**PLANNING COMMISSION
STAFF REPORT
AGENDA ITEM NO. 5.A.
April 19, 2016**

Project Address: No site address - Admiral Court and Commodore Drive
Assessor's Parcel No: 020-013-250, 020-013-260
Application No.: PDP-15-002, UP-15-006, AR-15-002
Zoning District: P-D (Planned Development District)
General Plan Classification: Visitor Services
Specific Plan Area: U.S. Navy Site and Its Environs Specific Plan
Prepared by: Paula Bradley, MCP, AICP, (650) 616-7038

Request for a Planned Development Permit PDP-15-002, Use Permit UP-15-006, Architecture Review Permit AR-15-002 to allow the construction of five-story, 69'-4" high, 152-room hotel, with 3,000 square feet of meeting/banquet space and below grade parking pursuant to Chapters 12.96.190, 12.96.200, 12.84.210, and 12.108.010 of the San Bruno Municipal Code. OTO Development, LLC (Applicant).

Premier II LED	Project Name:	Catalog Number:	Type
-----------------------	---------------	-----------------	------

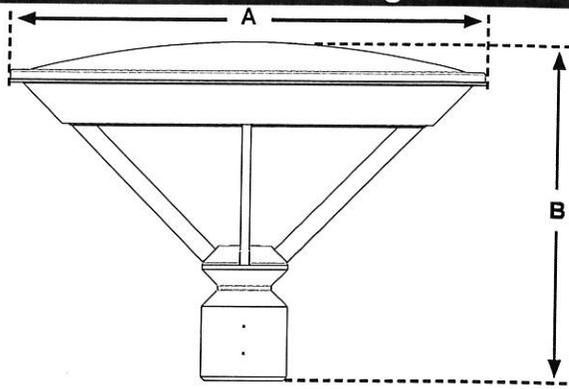
- Light standard fixture “Premier II” (Option 3) was selected as depicted in Exhibit I.
- The revised landscape plan as proposed dated 12/02/15 and the rendering of the east elevation is satisfactory.
- West elevation: propose a textured surface, or multiple textured surfaces, with a possible wave design, and consider extending it above the roof line. Provide a rendering for the Planning Commission meeting.
- Roof overhangs - not needed on the west elevation.
- Porte cochere - may have additional columns if structurally necessary, can be approved at staff level as part of the building plan review.
- Provide before and after elevations renderings with landscaping for review at the Planning Commission meeting.

West (REAR) Elevation
Scale: 3/32" = 1'-0"

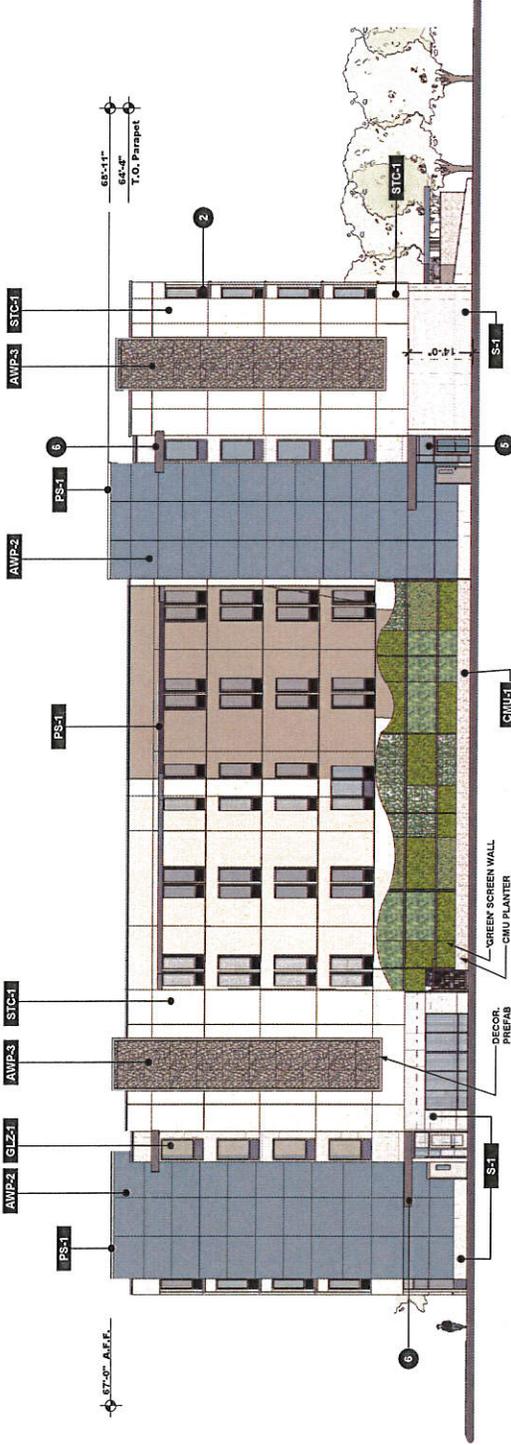
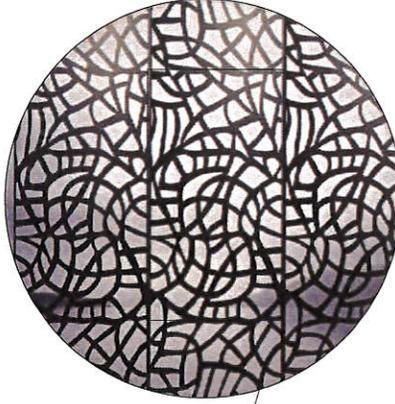
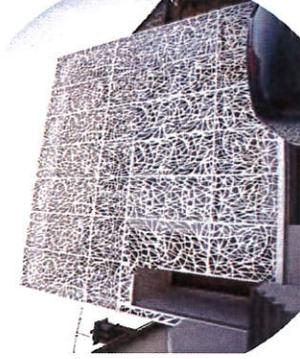
Elevations. The design guidelines of both the Navy Site Specific Plan and the Transit Corridors Specific Plan strongly encourages a strong base, middle and top for buildings. This was a strong element in the designs for the existing residential buildings in The Crossing. At staff's request, the applicant revised the elevation multiple times to achieve a design consistent with the design guidelines and plans which includes vertical and horizontal planes, recessed windows the curved porte-cochere canopy and expanded use of the limestone on the front northeast façade.. Finishes include both metal wall panels on the towers, and stucco panels, French limestone veneer, metal roof overhangs. The proposed west elevation was lacking in visual interest and the ARC members recommended articulation such as alternating stucco finishes or color panels and a wavy pattern or design to be presented at the Planning Commission meeting.

1. West elevation: Propose a decorative metal panel with a design reflecting the local context. Alternatively, propose a second option with a pattern incorporated into the panel surface to provide visual relief and interest.

In response to the ARC recommendations, revised plans were submitted dated January 5, 2016 with a new proposed West elevation detail for the Planning Commission consideration. It consists of two prefabricated framed vertical perforated panels from the second floor and extending above the parapet wall. The final pattern is to be determined and the proposed example is shown on Sheet DR-6A of the plans. The Committee’s recommendations were addressed and revised plans submitted and attached as Exhibit M.

HEIGHT STUDY JOB NO. 01040 DRAWING NO. DR-9
 DATE: 12.02.2015

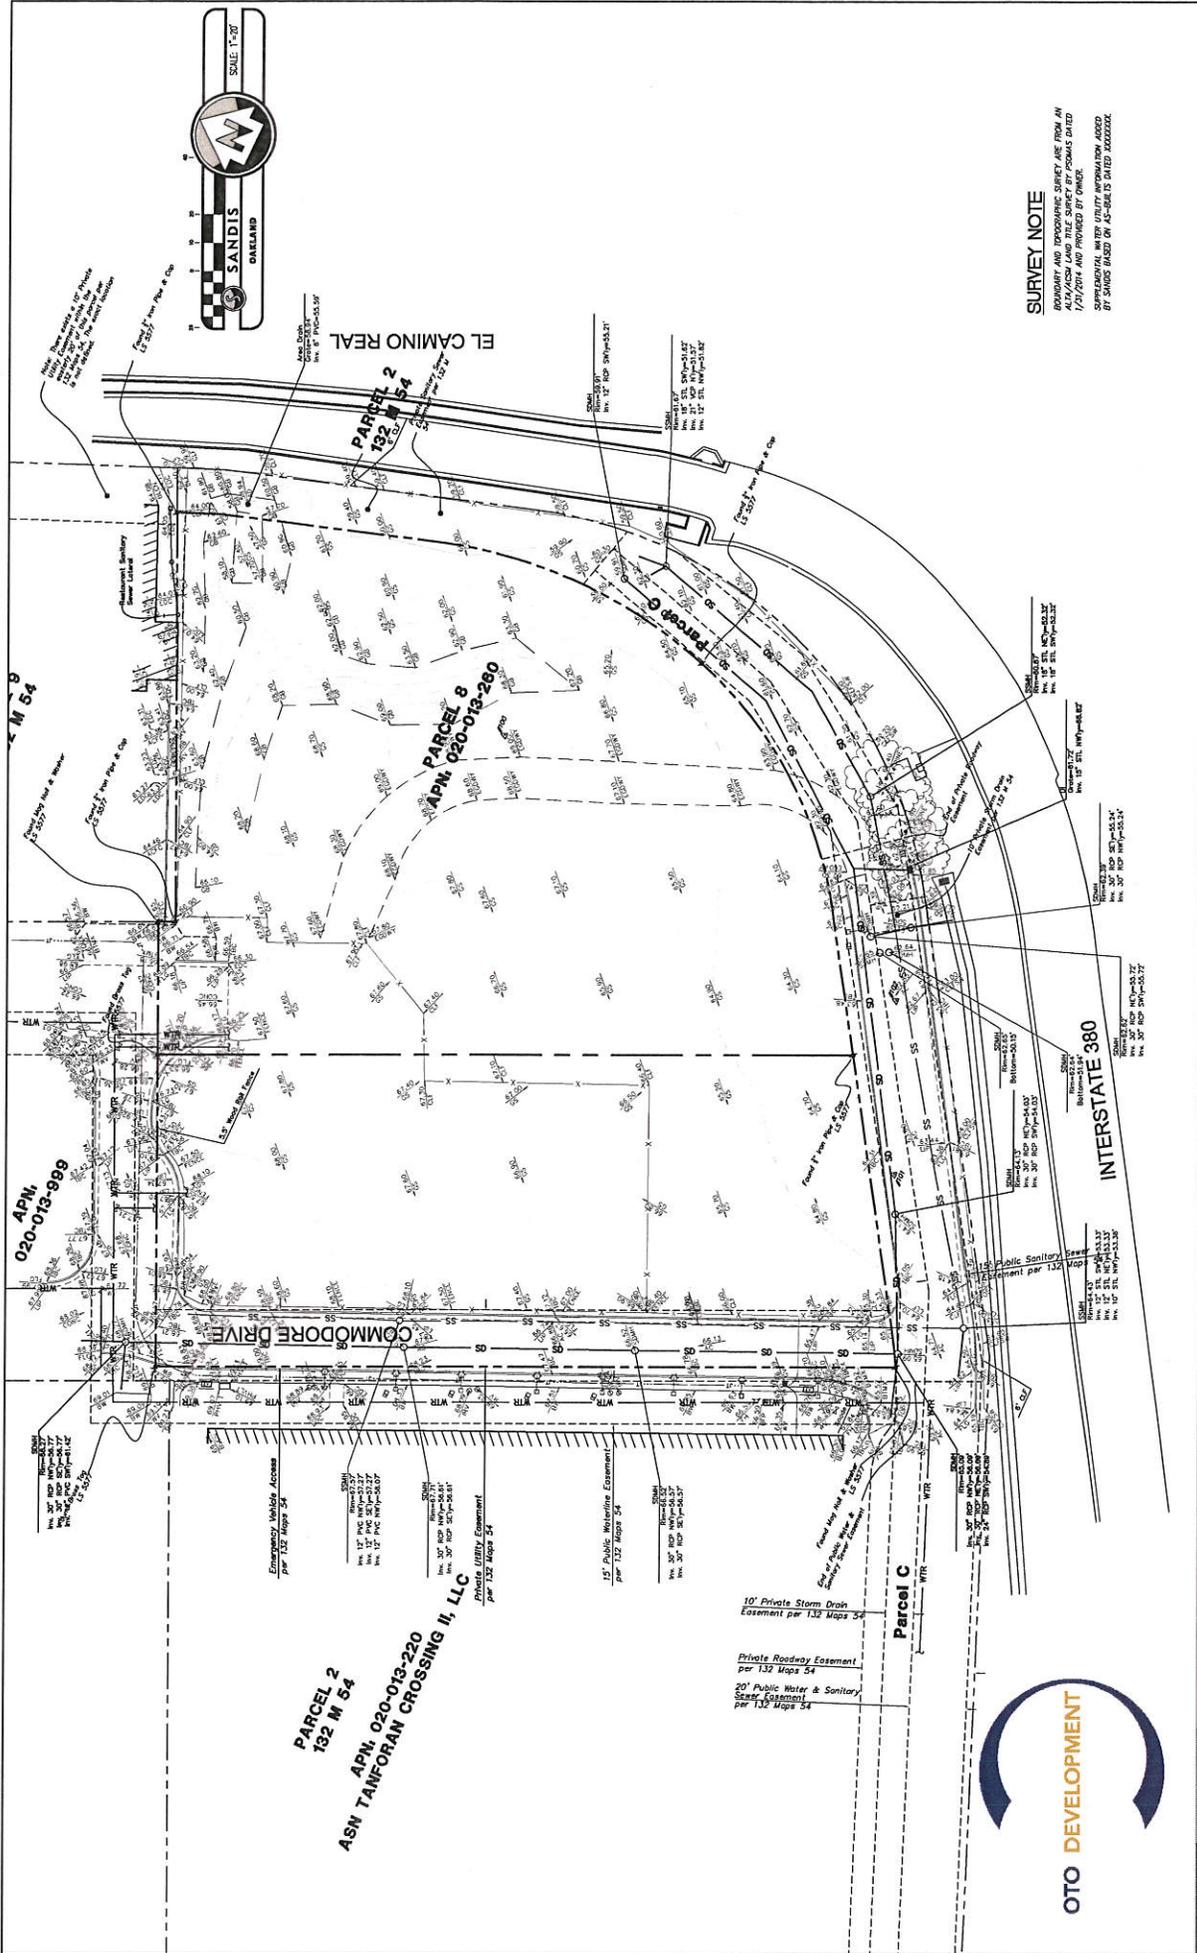
JM responded none to the floors of the hotel, only a few feet off the northeast tower elevation. As depicted in the revised drawings. A height study was added to the plans (Sheet D-9). An entirely new northeast elevation was presented with a curtain wall for the windows on floors two to five, a more simplified desirable design. The front entry canopy in front is curved. A new west elevation with a green wall at the courtyard and a medallions at the intersections of the stucco wall panels, with widened lines in between to add architectural interest. There are no additional recesses or roof overhangs as recommended at the November 12th ARC meeting.
